REQUESTED VARIANCE(S):

- Request(s):
 - To allow encroachment into the 50 foot stream buffer,
 - To allow encroachment into the 75 foot impervious setback (Chapter 14, Article 6, Section 5.a.i, ii)

COMMUNITY DEVELOPMENT STAFF ANALYSIS

RE: Bethany High School
Fulton County Public Schools
Stream Buffer Variance Application
LETTER OF APPEAL

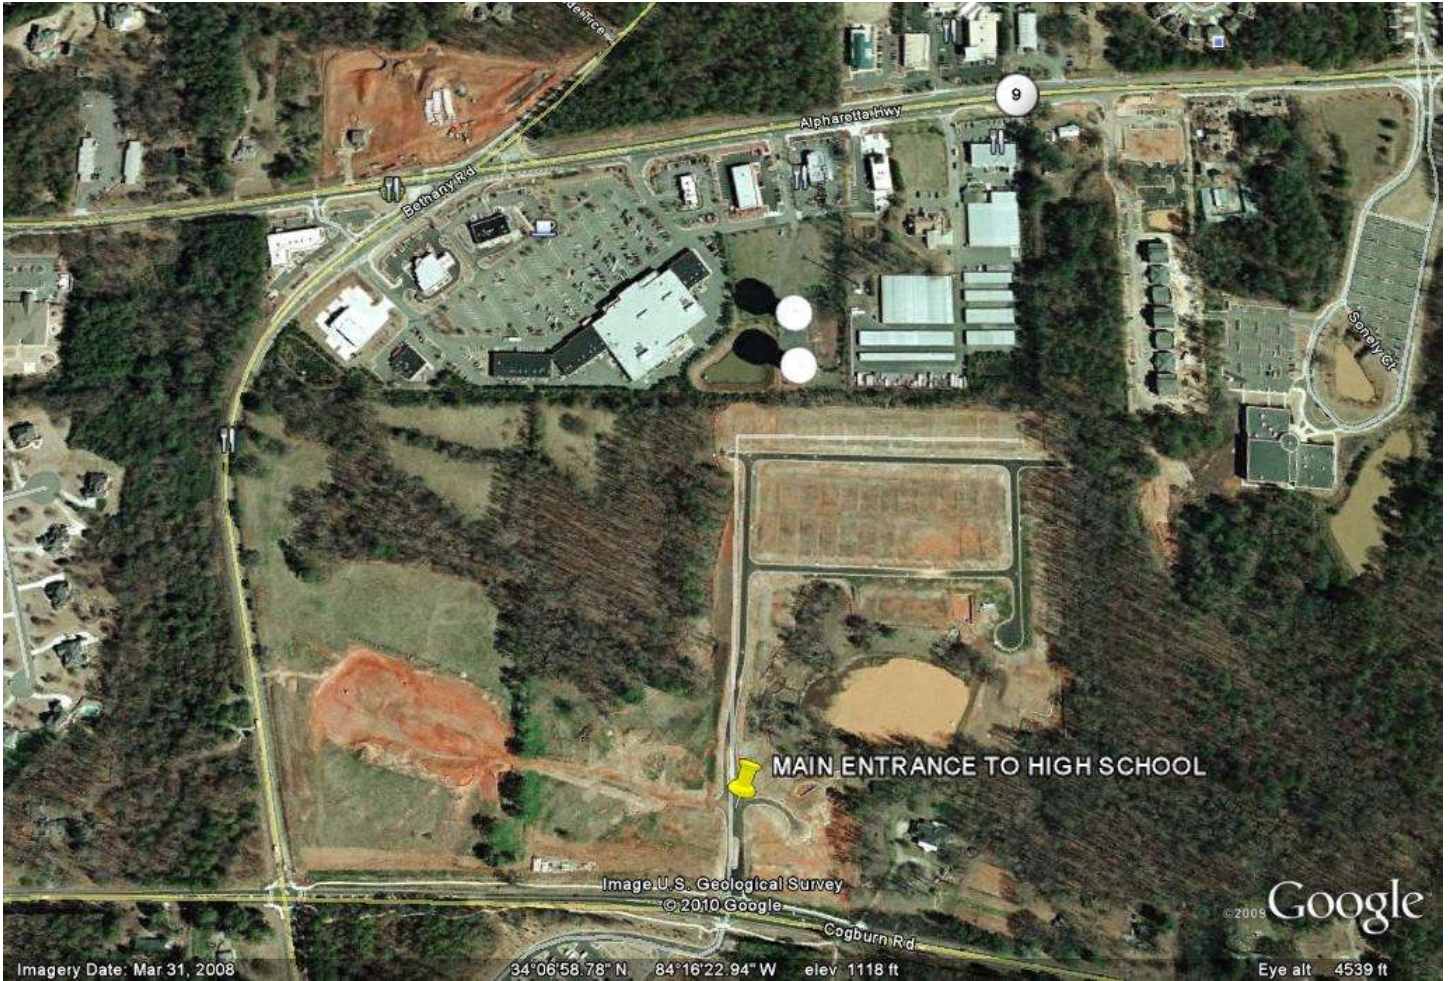
<p>DOT STAFF CONTACT SARAH LEADERS 678.242.2559</p>	<p>The current layout for the school provides 2 entrances. The traffic volumes assigned to each of the entrances were based on estimated bus trips and parent drop-off percentages. Approximately 30% of all vehicles entering or exiting the school will use the traffic light at SR 9 and Bethany. By providing the potential for a future connection from the school to SR 9, some of this traffic could be routed to an alternate entrance and would alleviate some of the volume at SR 9 at Bethany. The traffic measures needed for an entrance from SR 9 to the school and traffic routing would need to be studied in more detail. The provision for a future connection should be considered at this time in the planning stage.</p>

ALTERNATIVE SITE PLAN

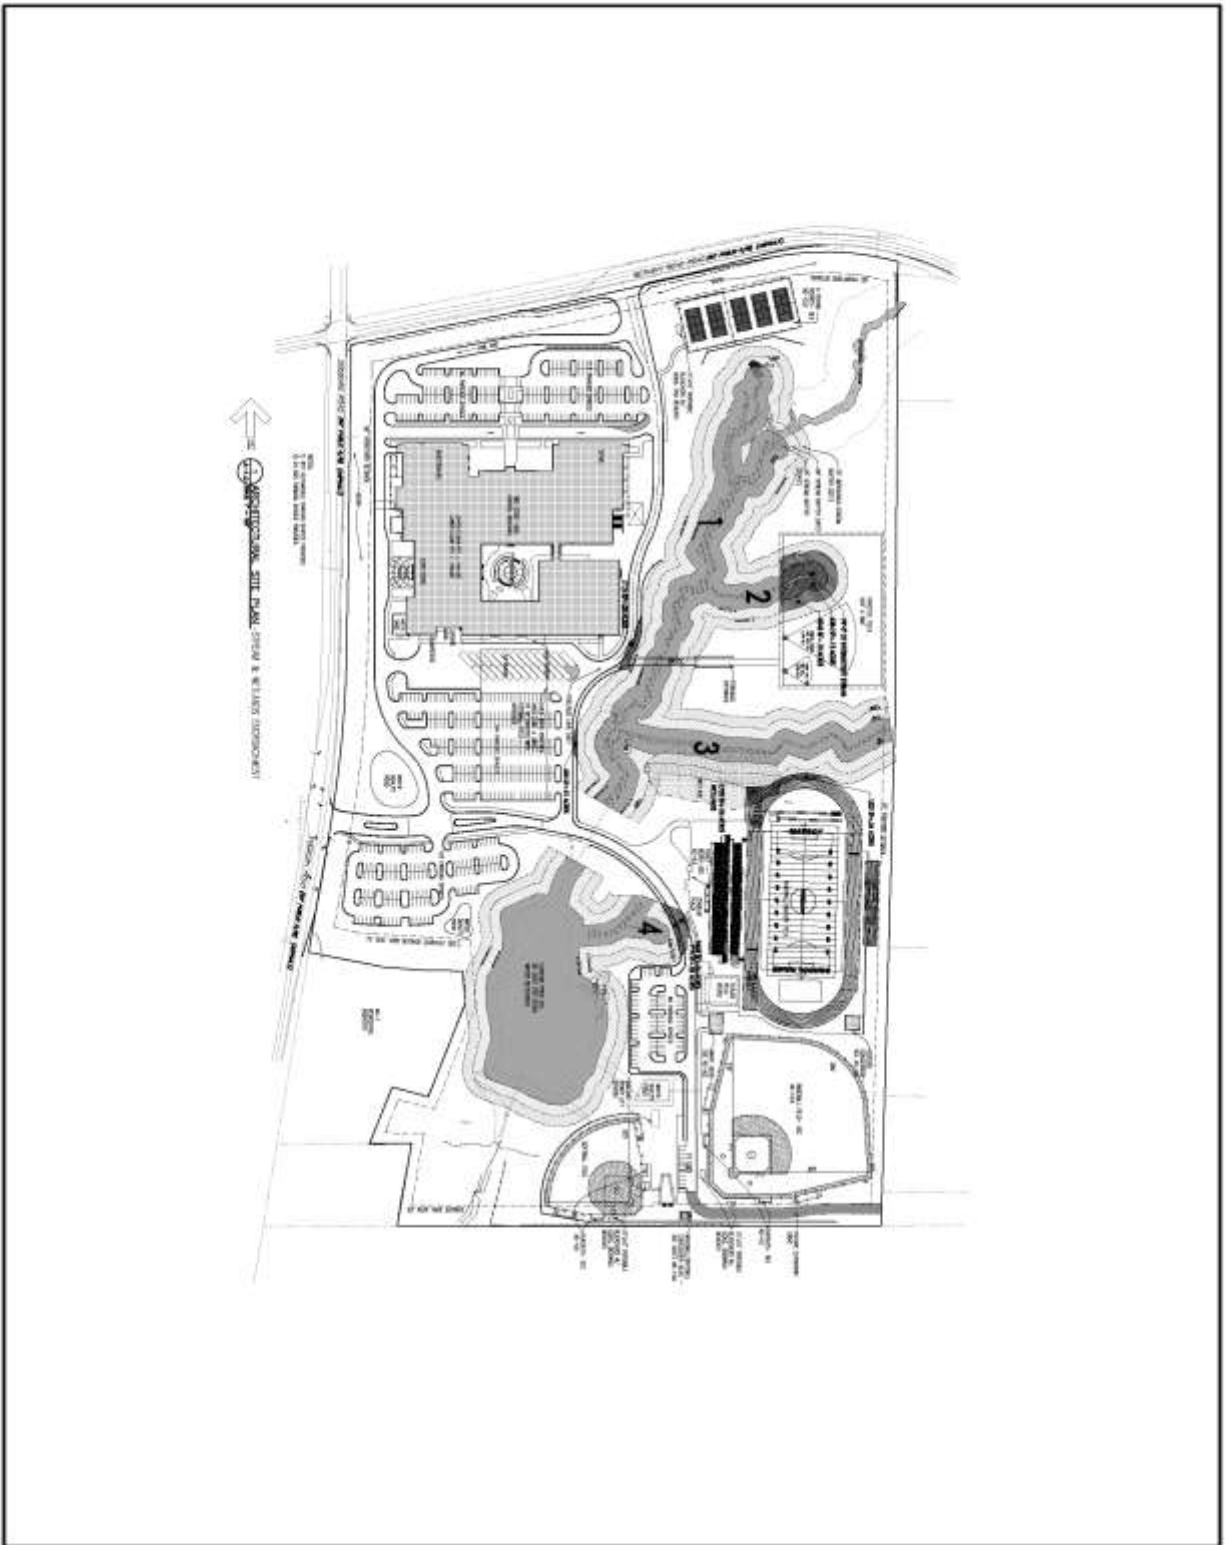
Per the list of variance consideration, Staff has received an alternative plan from the applicant. This plan dated "Received January 4, 2010," shows the 234x360 foot practice field oriented in a north-south direction. The BOE has stated that this is the ideal orientation due to sun and visibility concerns. This option would produce an encroachment into the 75 foot impervious setback and 50 foot stream bank buffer by approximately 99'6". This option would also require a variance for encroachment into the 25 foot state buffer, from the State of Georgia Environmental Protection Division (EPD). (See Arborist comments pertaining to these options).

<p>The other would require the piping of an intermittent stream at its origin with fewer trees removed and less altering of the area.</p> <p>Design submitted showing sports field with a north – south orientation....What appears to be an insignificant intermittent stream has been observed to have little, but continuous flow. There is no springhead located, rather an area of ground seepage as the origin. Again, there is little flow, with no well developed stream banks. Water does not have continuous flow towards larger stream as it goes subsurface.</p> <p>Most of the central to east central area of the sports field, as shown, has much more level terrain than the central/west central as well as fewer trees proposed for removal.</p> <p>The field located with this orientation would impact the northern intermittent stream, requiring piping in this area and could possibly improve/enhance the stream. Fewer trees would be removed, trees which are lone groups and areas with much scrub. Less grading would be required as well as less retaining wall in both height and length. Much of the area in this plan is open field.</p>
